**PLANNING COMMISSION REPORT**  
**Regular Agenda -Public Hearing Item**

**ITEM NO. 5B: PRELIMINARY DEVELOPMENT PLAN FOR ALVAMAR; 1800, 1809, 2021 CROSSGATE DR (SLD)**

**PDP-16-00052:** Consider a Revised Preliminary Development Plan for Alvamar PD, Lots 1, 2a, 2b, and 3, located at 1800, 1809, & 2021 Crossgate Dr. Submitted by Paul Werner Architects, for Eagle 1968, LC, (contract purchaser). Alvamar Inc. is the property owner of record.

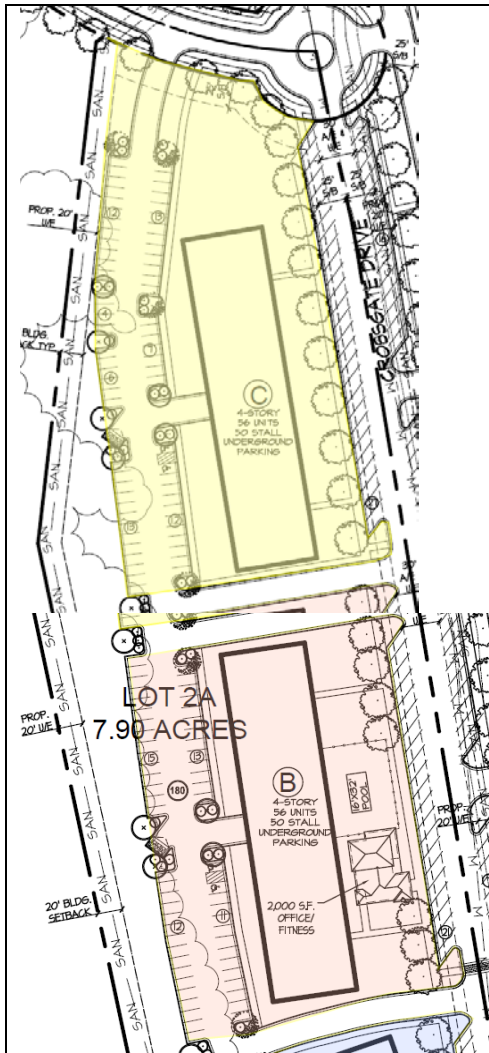
**Lot 2A Parking Conclusion.** Lot 2A is short 4 spaces associated with the pool/clubhouse space for the Multi-dwelling uses. Off-street parking related to the chapel use is not accounted for in either the residential or non-residential list proposed by the applicant but should be with the Final Development Plan. This parking summary excludes the parking located along the “private street”. Clearly the building is designed and oriented that access to the residential units can be accommodated either from the surface parking lot or the angled parking spaces along the private street. However, some uses included in the non-residential part of the development require use of these spaces especially during high volume events such as tournaments and large reception type uses. This will result in a slight impact on the multi-dwelling uses up to approximately 4 spaces. The location of the chapel use near Building A is the most likely to impact the residential parking.

Additional parking is recommended for the residential uses located on lot 2A. Options for providing additional parking include reducing some of the small islands, extending parking further to the north, adding parking to the north side of Building C and/or increasing the number of garage spaces within the buildings.

- Each residential building located on Lot 2A requires 110 spaces.
- Each building includes a garage with 50 spaces.

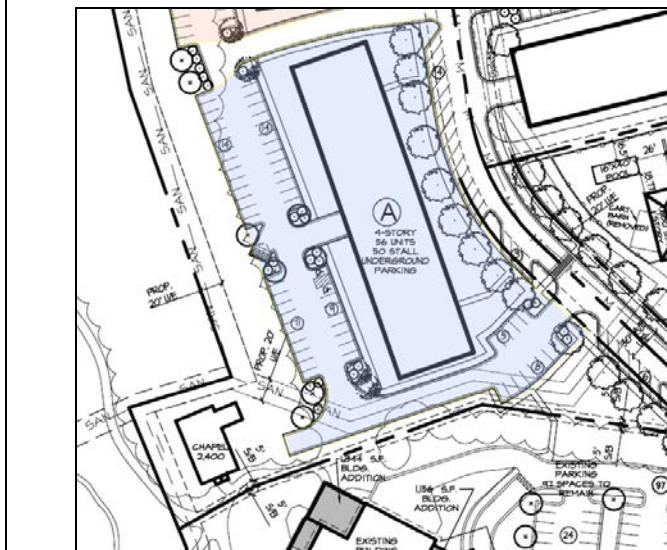
**Building B** includes the pool/clubhouse use located along the east side of the building. This space provides an amenity to the apartments separate from the golf course facilities. This is a new revision to the plan. This building includes 50 garage spaces and 51 surface spaces located to the west of the building. Parking for the apartments and the pool/clubhouse area require 114 spaces. The garage and surface parking provide a total of 101 spaces, excluding the 21 spaces along the “private street segment”.

**Building A** includes 50 garage spaces and 61 surface spaces located to the west and south of the building. Parking for the apartment building is met without the 17 “on-street parking spaces”.

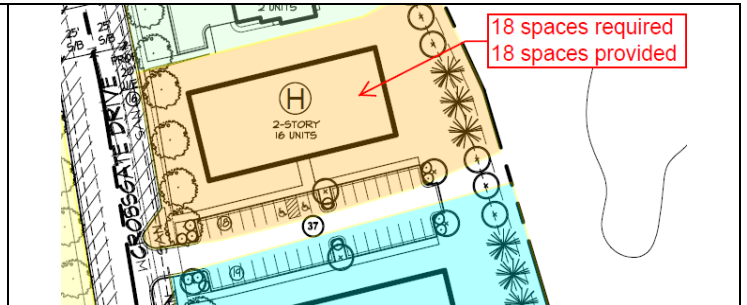
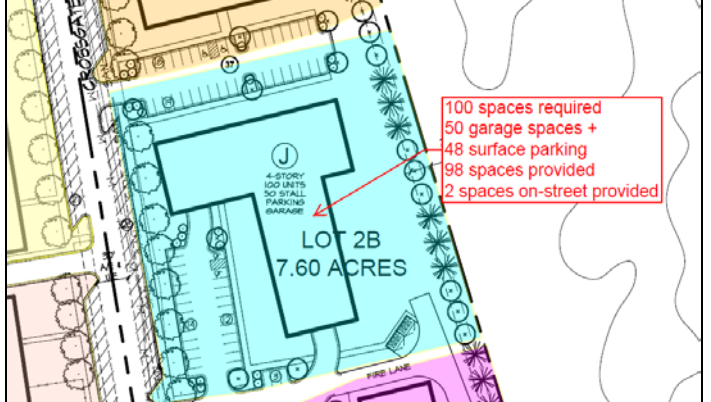
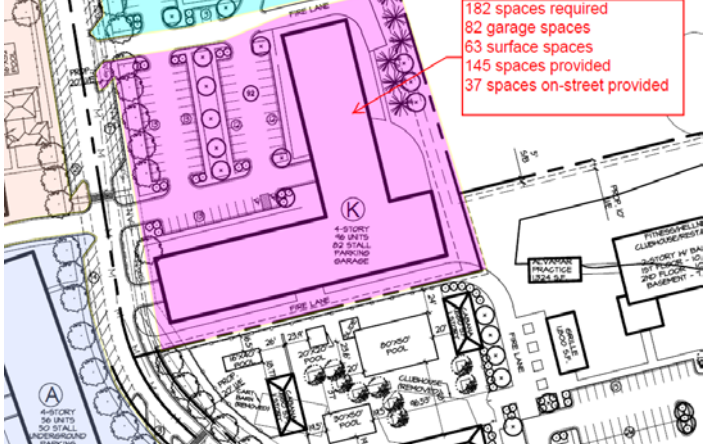
**Buildings D, E, F & G** are designated on the Preliminary Development Plan as 1 story units. Each unit has either one or two bedrooms. All units have an attached one or two car garage. Off-street parking is met in the garages of the units. Buildings D and E are proposed as one-bedroom units while F & G are proposed as two-bedroom units. A total of 12 bedrooms are provided in the 8 duplex units. Off-street parking is met for this use.

**Building H and K** are proposed *Multi-Dwelling* residential use buildings. Building H includes 16 one-bedroom units. Building H does not propose covered or garage parking. The plan shows 18 spaces located immediately adjacent to the building on the south side. Parking for this building is met.
